PRODUCT / PROCESS CHANGE NOTIFICATION

1.1 Company		STMicroelectronics International N.V
1.2 PCN No.	MDG/19/11628	
1.3 Title of PCN	ST Muar (Malaysia) HD line capacity extension STM8 & STM32 LQFP 10x10 64L additional products	
1.4 Product Category	STM8 & STM32 LQFP 10x10 64L listed products	
1.5 Issue date	2019-07-02

PRODUCT/PROCESS CHANGE NOTIFICATION PCN 11628 – Additional information

ST Muar (Malaysia) HD line capacity extension STM8 & STM32 LQFP 10x10 64L additional products

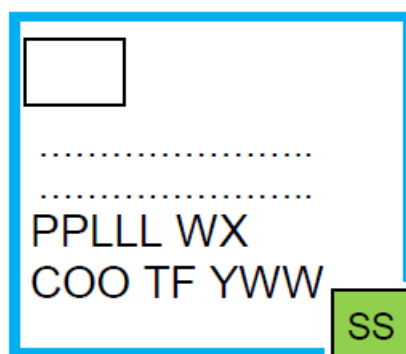
Pin1 identifier can change in terms of form and positioning.
Marking position and size could be different upon assembly site, without any loss of information.

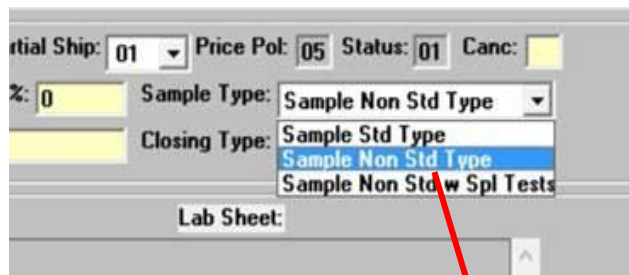
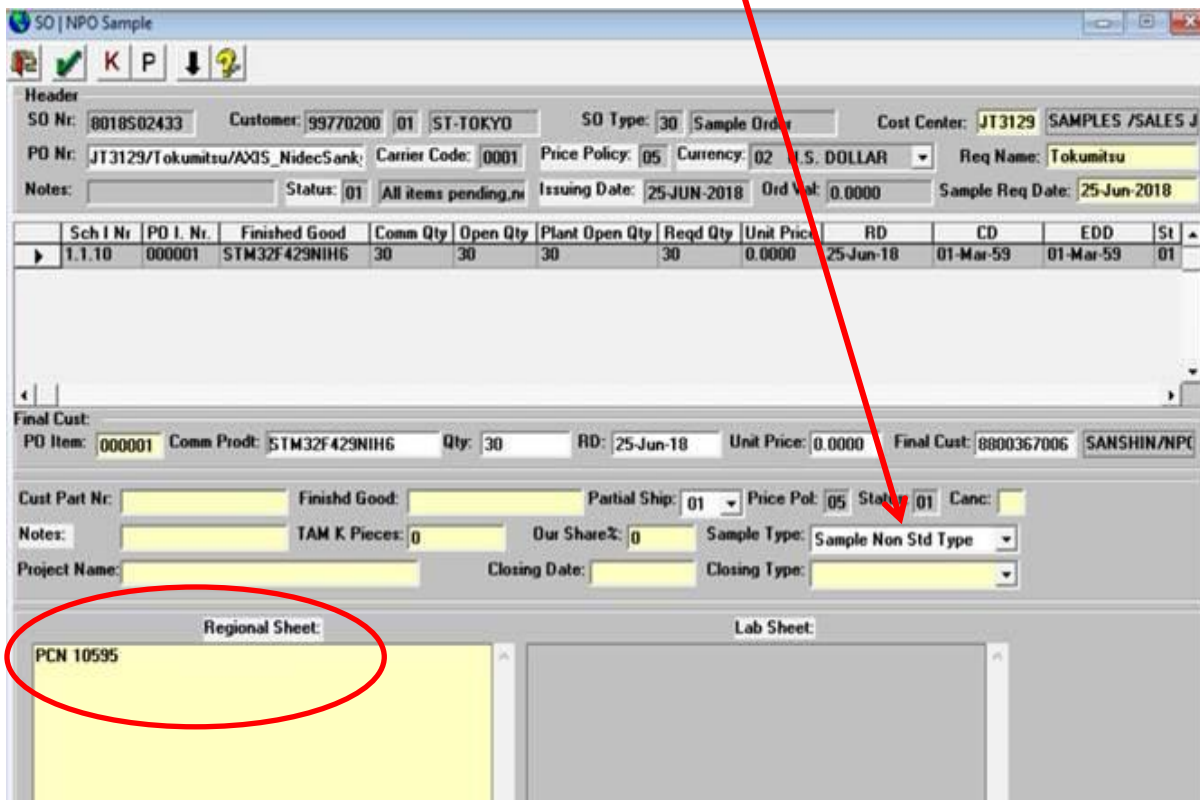
In case parts **PP** code is 99 then check Enhanced traceability in marking (**SS** marking)
 Products from existing ST Muar Malaysia assembly line doesn't have SS marking while
 products from extended capacity line will have SS marking.

SS marking is inserted at the bottom right corner and indicates the subplot assembly traceability information.
